TO: Planning & Zoning Commission  
FROM: Heather Milway, Village Planner  
THUR: Charity Jones, AICP, Planning & Economic Development Director  
SUBJECT: Case 15-08 Estates of Montefiori Preliminary Planned Unit Development  
DATE: June 11<sup>th</sup>, 2015

Case No. 15-08  
Project Name Estates of Montefiori Preliminary PUD and Rezoning

PRELIMINARY LANDSCAPE PLAN

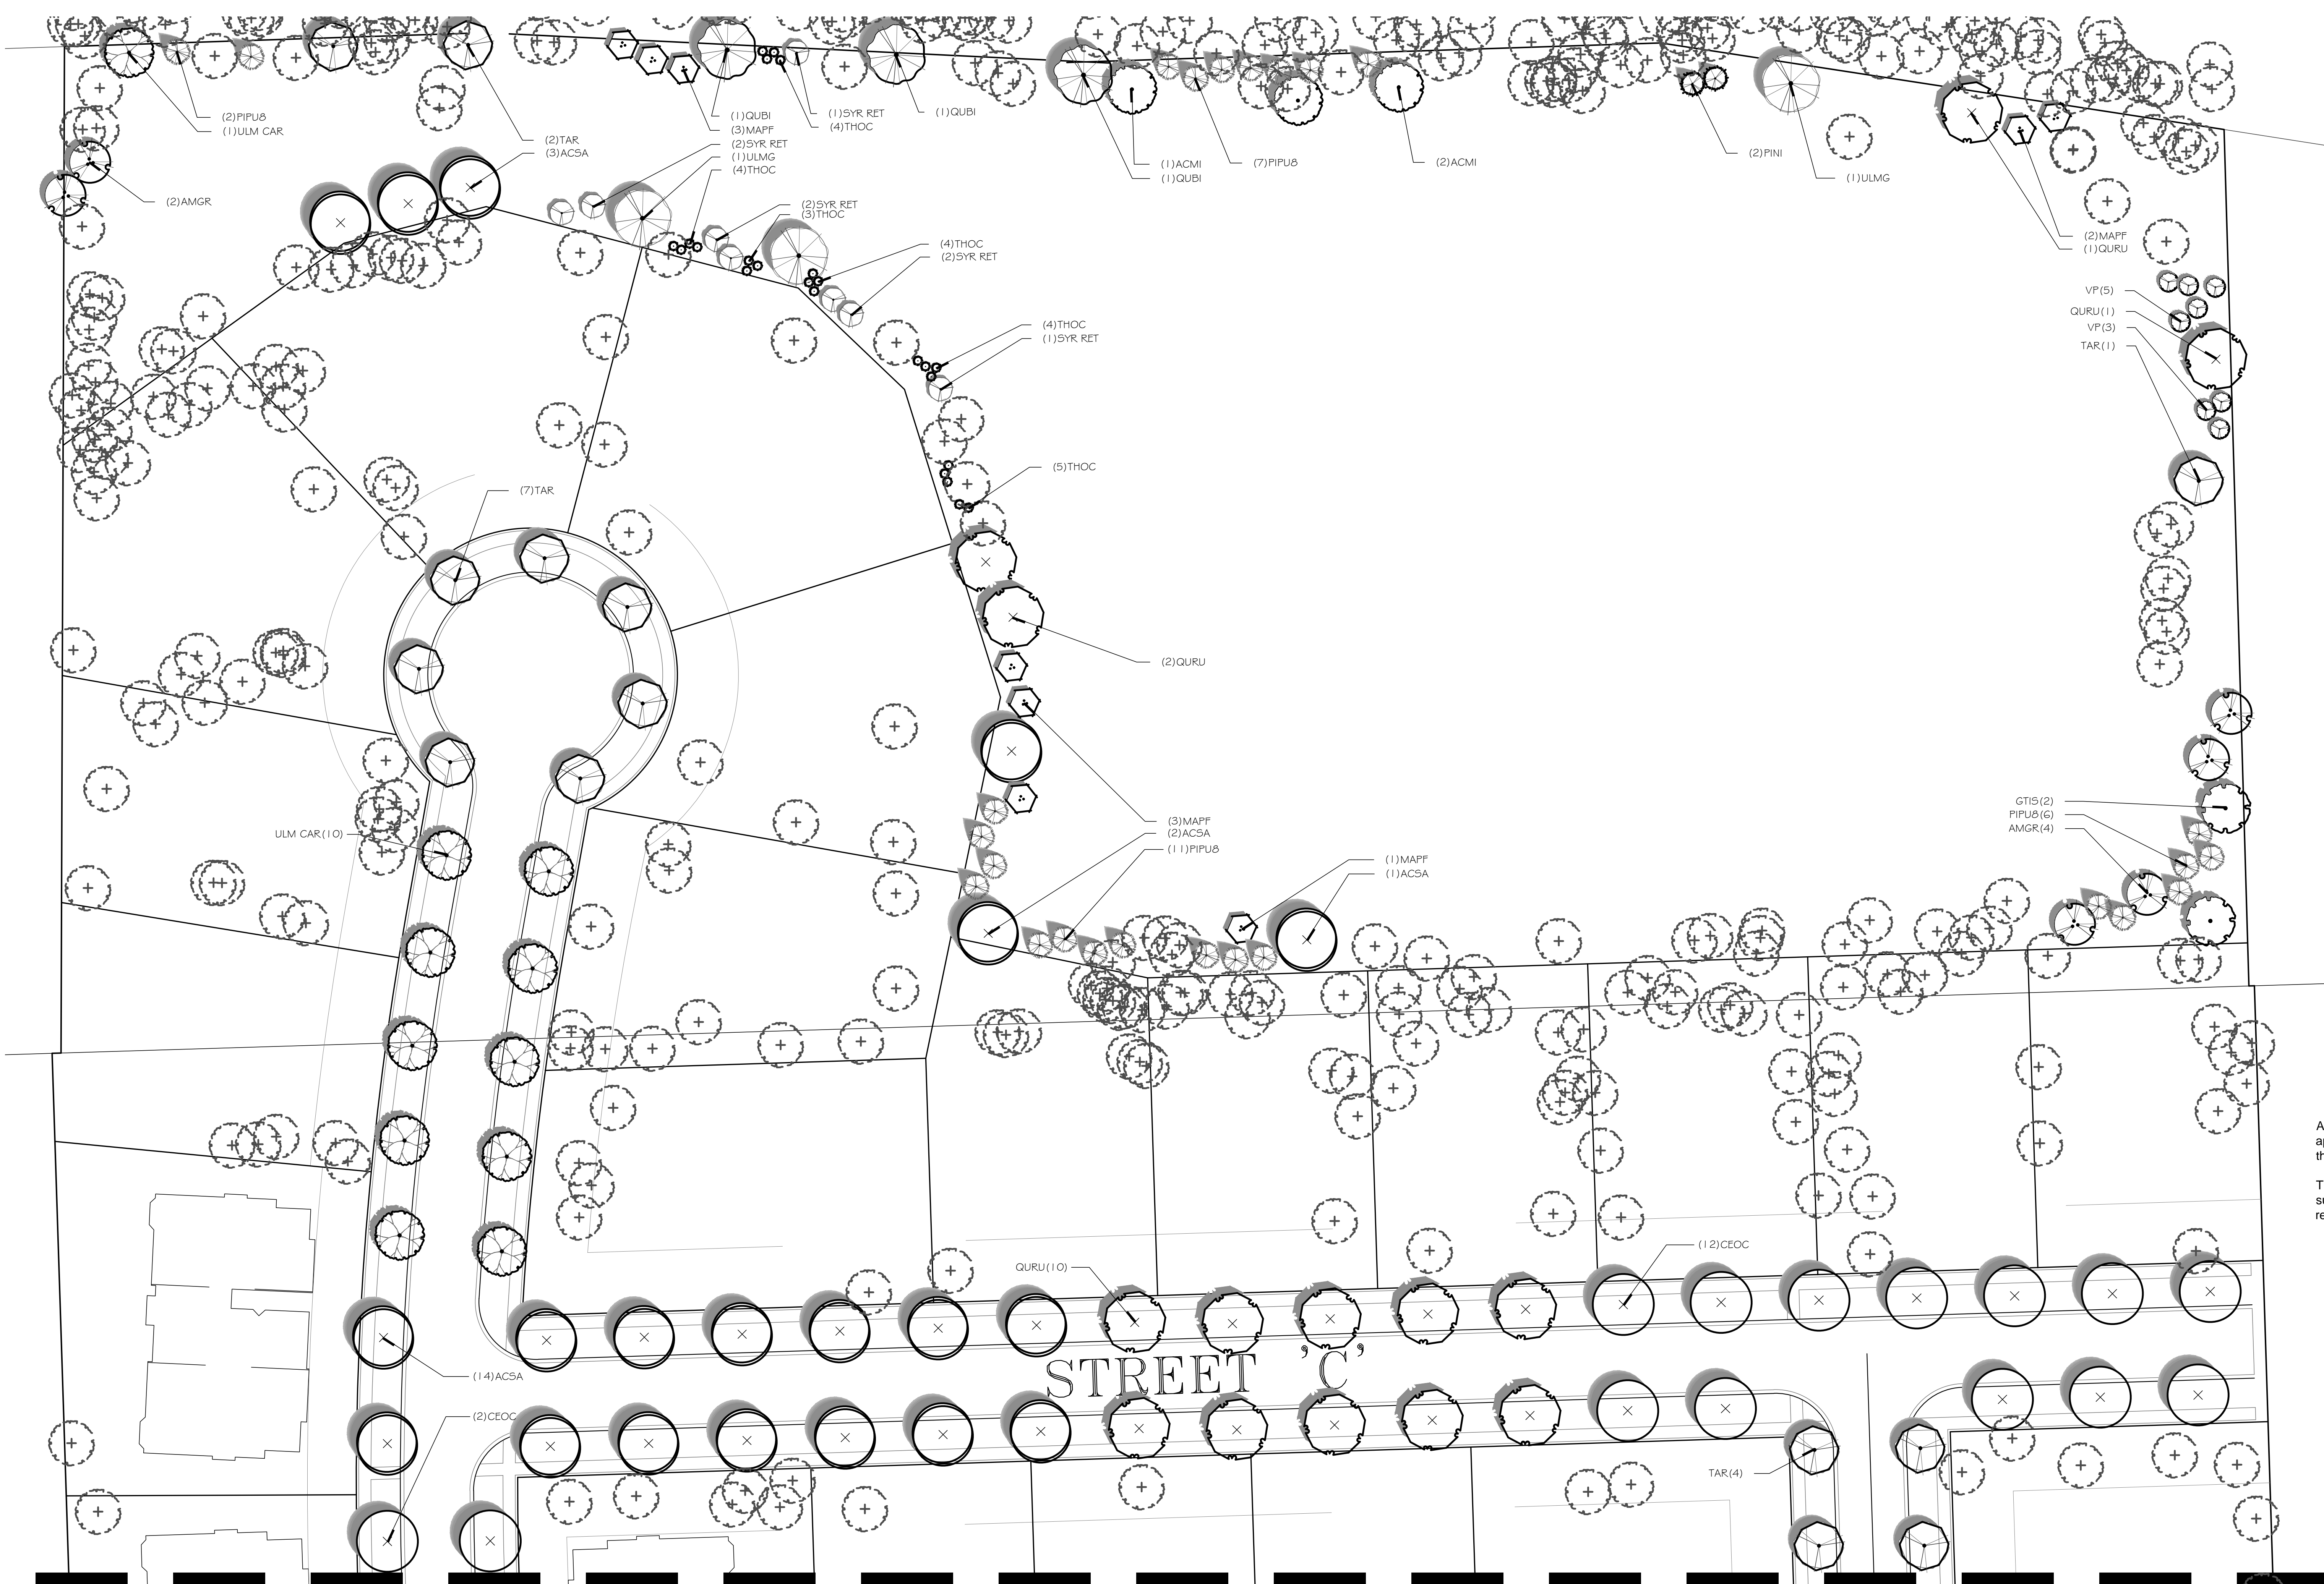
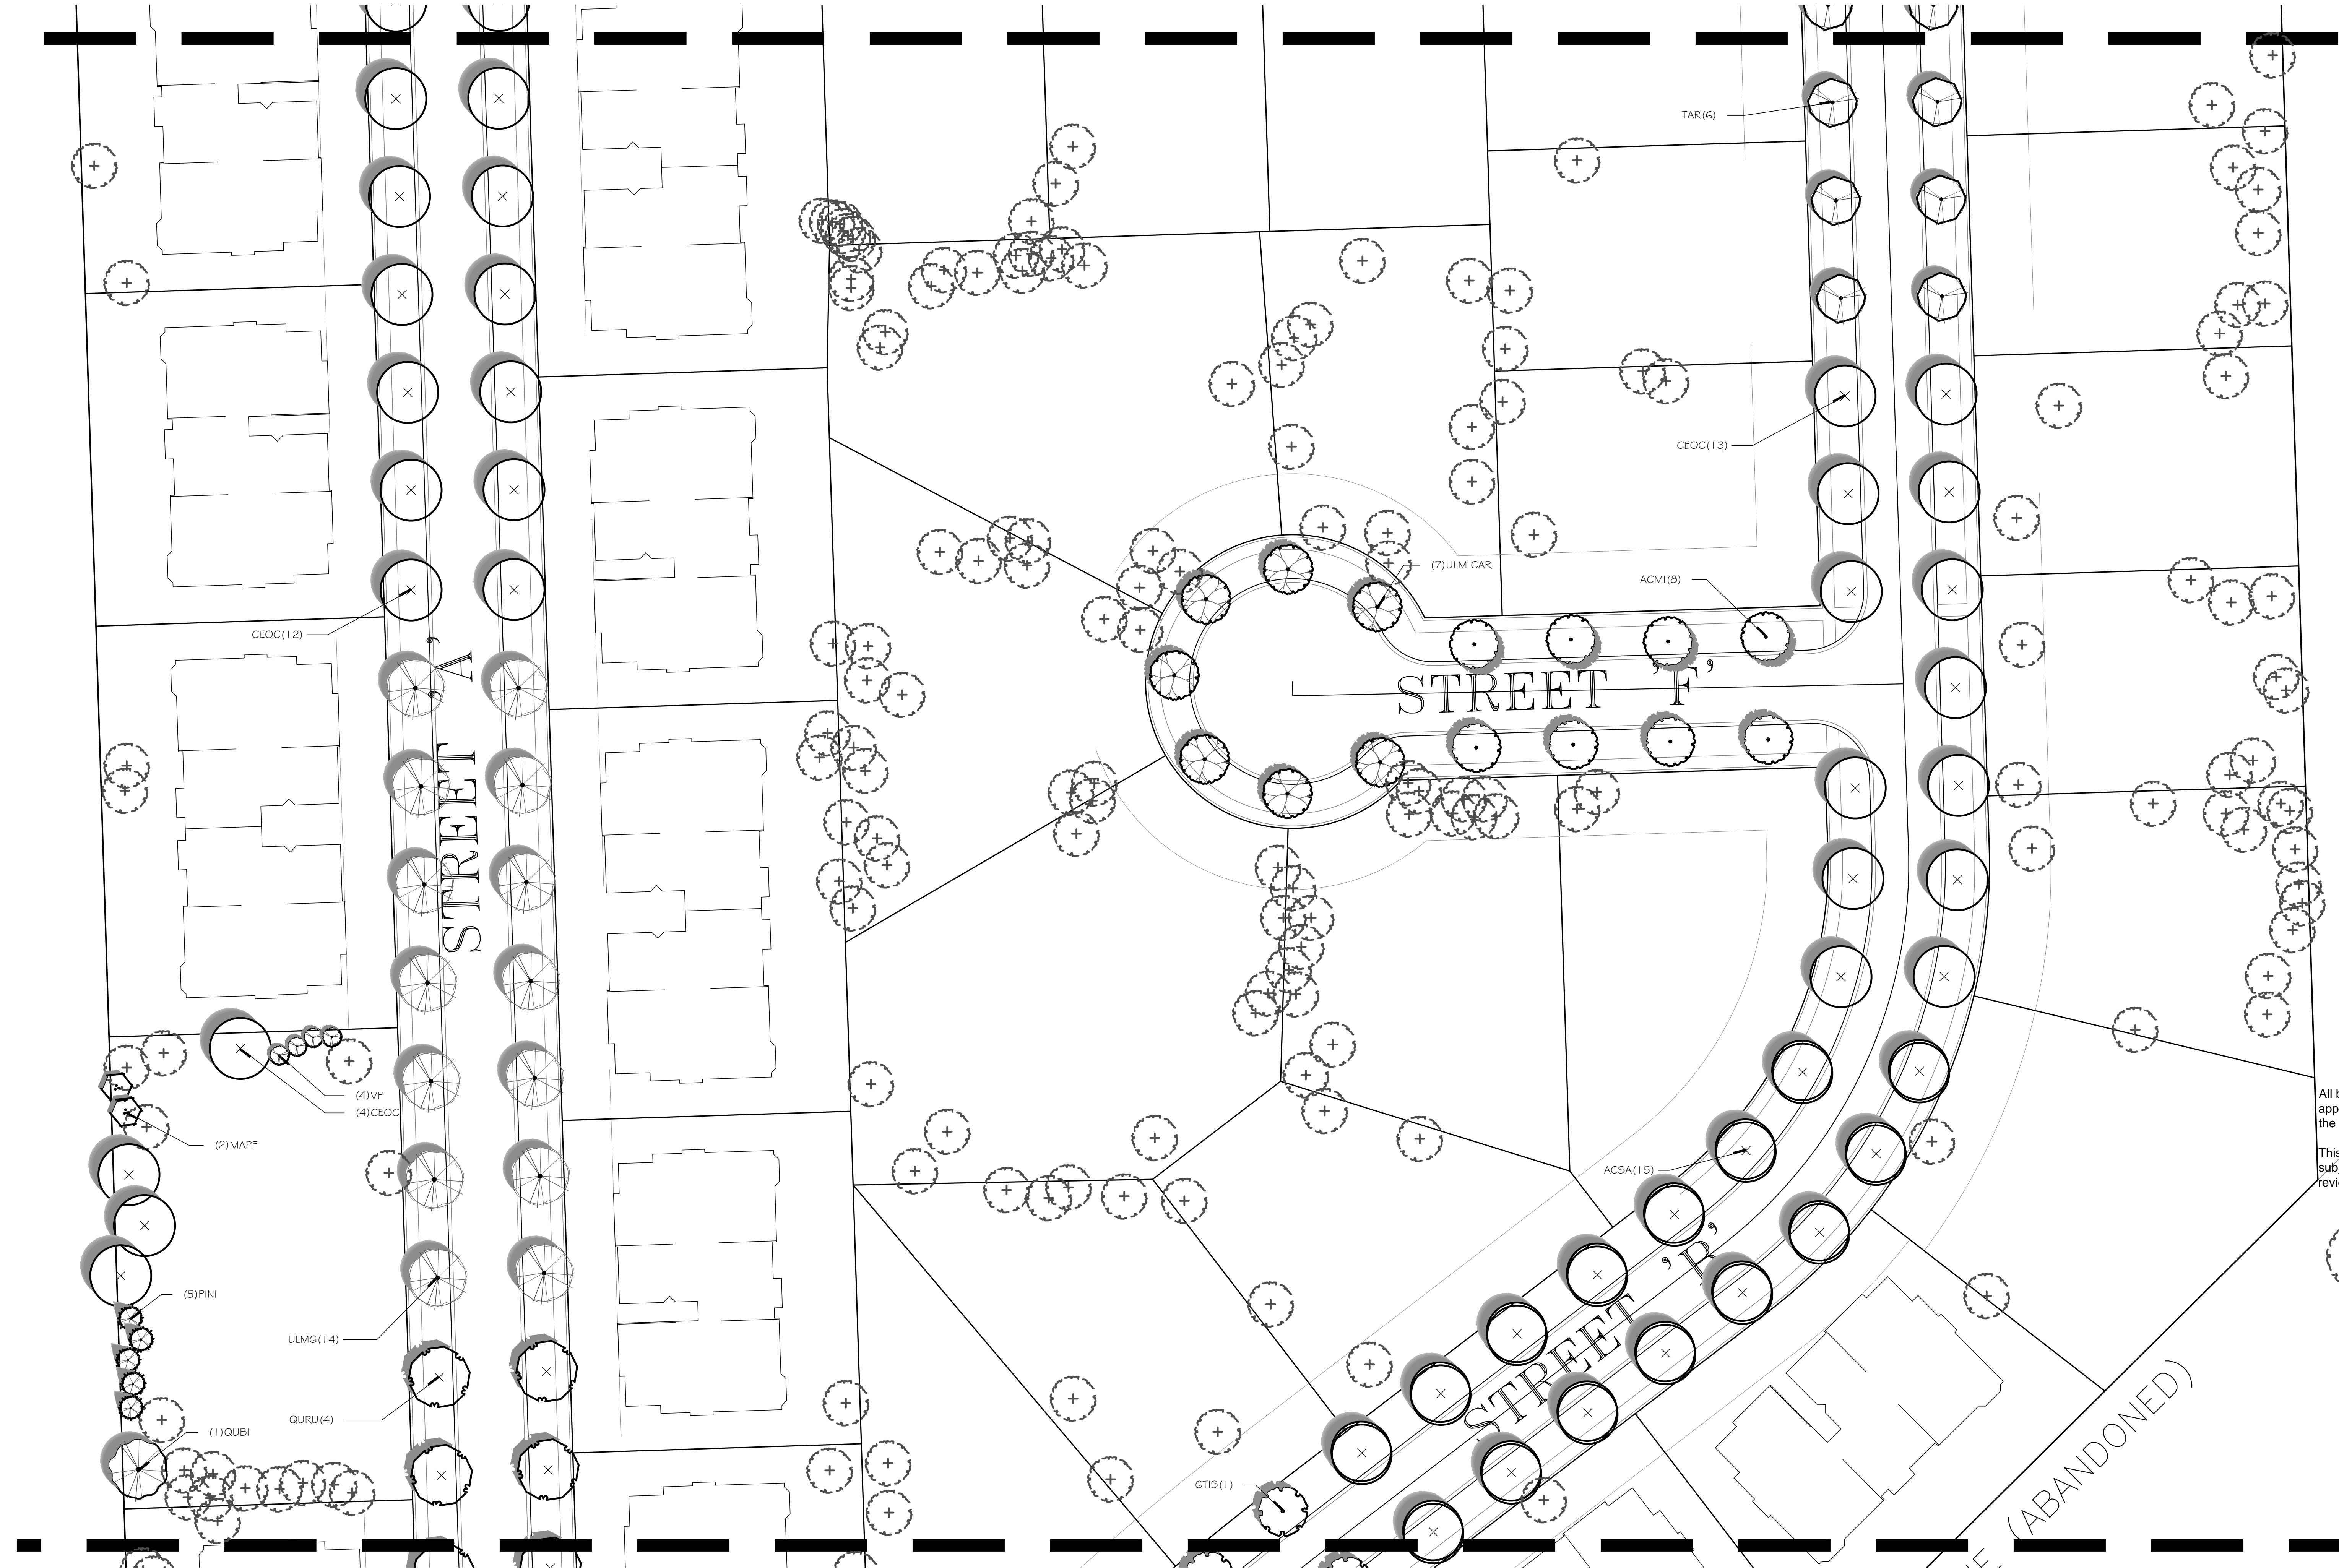
**Landscaping.** The Village Arborist has reviewed the proposed plans and comments that the tree survey was not complete and thus the request for a tree preservation waiver cannot be reviewed as the condition, age, and species of the existing trees cannot be examined to determine which are suitable to preserve or be mitigated for, if removed. Additionally staff recommends that tree preservation be used to achieve the goal screening the ComEd ROW from the townhomes and town homes from single family on lots 25-31. The landscape plan was also not complete and could not be reviewed for consistency with the UDO. The landscape plan and tree survey must be resubmitted to be fully evaluated. The Village Arborist's full comments are attached.

The Landscape Plan by Wingren Landscape dated 5.19.15 is a Preliminary Plan. It does, however, include some of the existing trees that are to be saved. The plan includes this Note: "Final decision of existing trees to remain will be based on health, species, and condition of the tree as well as final engineering". This comment is more in line with Chapter 17.20 of the Lemont Unified Development Ordinance. This approach is certainly more appropriate at this stage of the process than a "full waiver for the preservation of trees on the property".

This exhibit is titled "Tree Preservation Plan". There is no Tree Preservation Plan. There is an Existing Tree Survey that includes tag numbers from 191 through 3263. The tree survey also includes a tree data listing format for tree species, size, and condition. The survey includes this data information for about 7% of the 3,702 trees that were tagged. This lack of information is another indication that a "full waiver for the preservation of trees on the property" is not appropriate at this stage of the process.

5. Revise the landscape plan to include proposed tree preservation measures. Additionally, include more landscaping behind the proposed townhomes on "Tuscany Ln" to screen the units from the Com Ed right of way.
